1 **Request IR-101:**

Maritime Link Project (NSUARB ML-2013-01)  
NSPML Responses to Small Business Advocate Information Requests

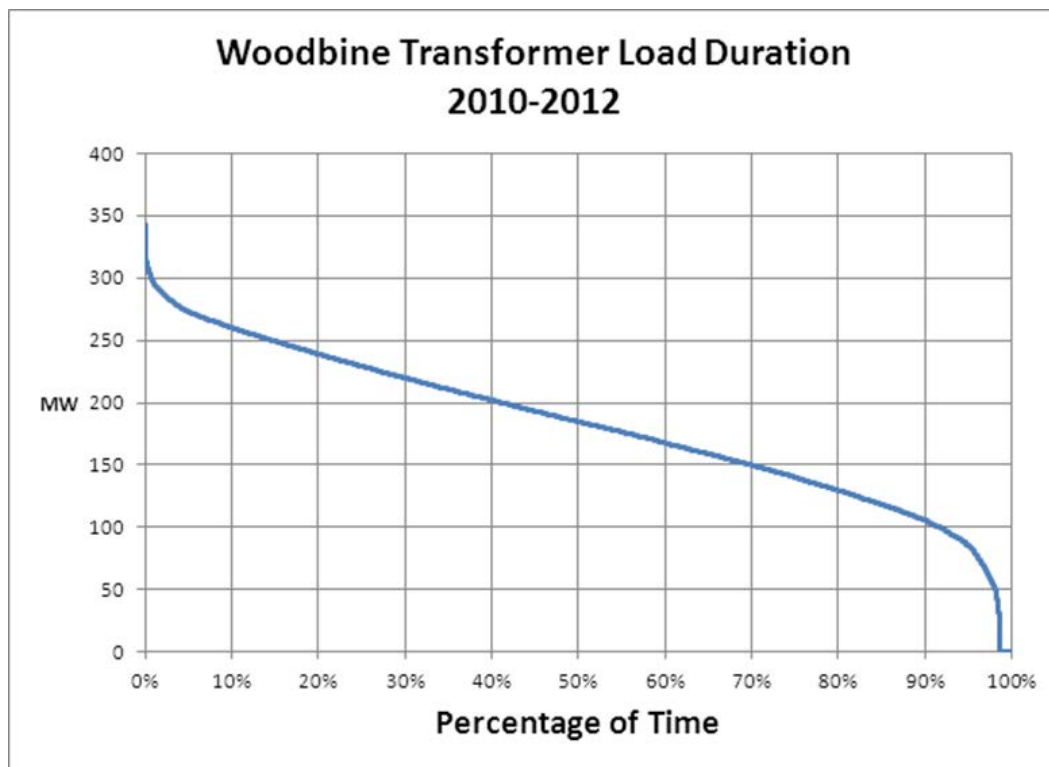
3 **With reference to Appendix 3.01, page 55, please provide the current loading data on the**  
4 **Woodbine substation and explain why up to 500 MW of additional power flows through**  
5 **the Maritime Link would require doubling the connection capacity at Woodbine**  
6 **substation.**

10 A load duration curve for the existing Woodbine 345 kV-230 kV is provided below for the three  
11 period from 2010-2012. See also response to CA/SBA IR-170.
